# UNITED STATES PATENT AND TRADEMARK OFFICE

APPLICATION NO.	FILING DATE	FIRST NAMED INVENTOR	ATTORNEY DOCKET NO.	CONFIRMATION NO.
10/796,692	03/09/2004	Colby Nash	FY.51040US1A	2923
20995 7590 05/09/2007 KNOBBE MARTENS OLSON & BEAR LLP 2040 MAIN STREET FOURTEENTH FLOOR IRVINE, CA 92614			EXAMINER BROWN, DREW J	
			ART UNIT 3616	PAPER NUMBER
			NOTIFICATION DATE 05/09/2007	DELIVERY MODE ELECTRONIC

# Office Action Summary

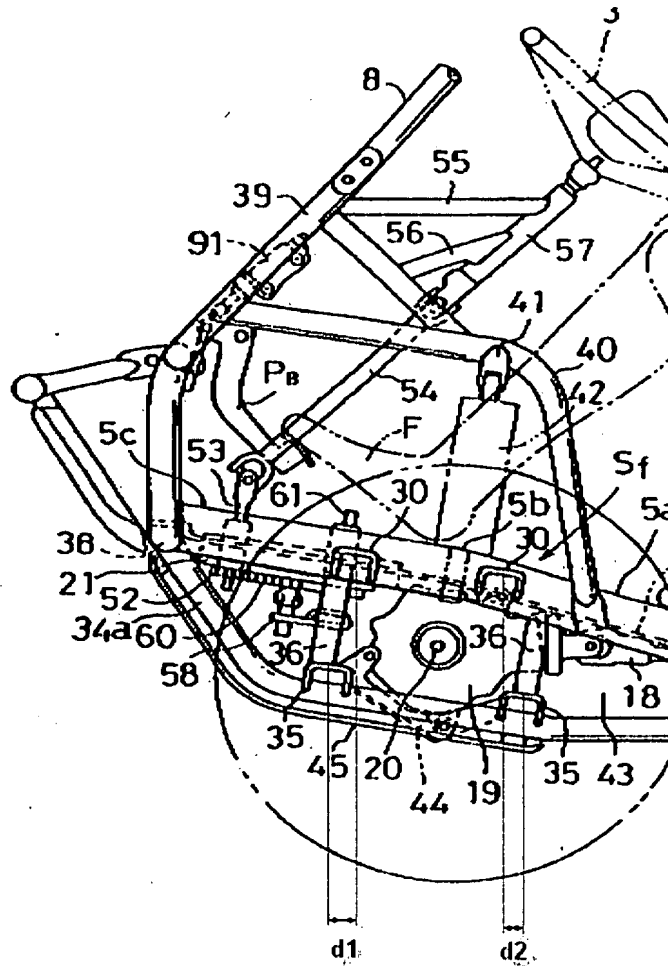
With respect to claim 1 and 32, Furuhashi et al. discloses an off-road vehicle comprises a frame (1) extending generally fore to aft, at least one wheel (2), and first (31)

and second (33) suspension arms, each including a plurality of ends and being configured to suspend the wheel from the frame (Figure 4), the frame including two frame members (5 and 34) extending generally fore to aft, the vehicle further comprising front (30) and rear (35) sets of retainers being coupled to the frame members, the retainers of at least one of the front and rear sets being spaced apart from each other in a fore-to-aft direction with a fore-to-aft spacing between the retainers of the rear set (Figure 5), each retainer of the front set being configured to retain an end of a respective suspension arm (31) and each retainer of the rear set being configured to retain an end of a respective suspension arm (33) so as to permit the respective suspension arm to swing relative to the respective set of retainers (Figure 4). A front retainer of each set is configured to retain a front end of a respective suspension arm in a manner permitting the respective suspension arm to swing relative to the respective set of retainers (Figure 4), the front retainers being spaced apart from each other in a fore to aft direction by a distance which is different than a distance by which the rear retainers are spaced apart from each other in a fore to aft direction ( $d1 > d2$  as shown in Figure below).

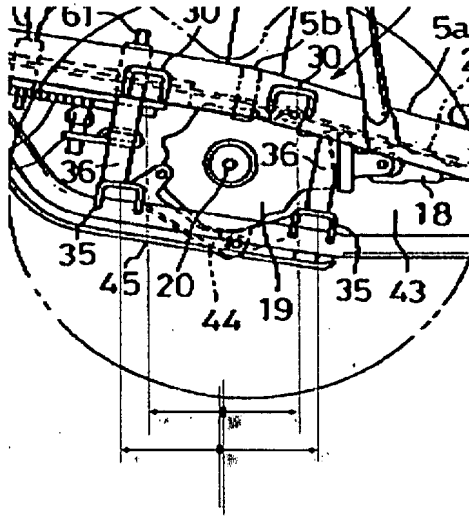
With respect to claim 36, a frame (10) and upper (31) and lower (33) suspension arms, the frame extending generally horizontally fore to aft, the upper and lower suspension arms each including two ends being pivotally coupled to the frame (Figure 4), the ends of upper suspensions arm being spaced apart from each other fore to aft at a first length, the ends of the lower suspension arm being spaced apart from each other fore to aft at a second length, wherein a midpoint of the first length is not aligned with a midpoint of the second length along a vertical line (see Figure below).
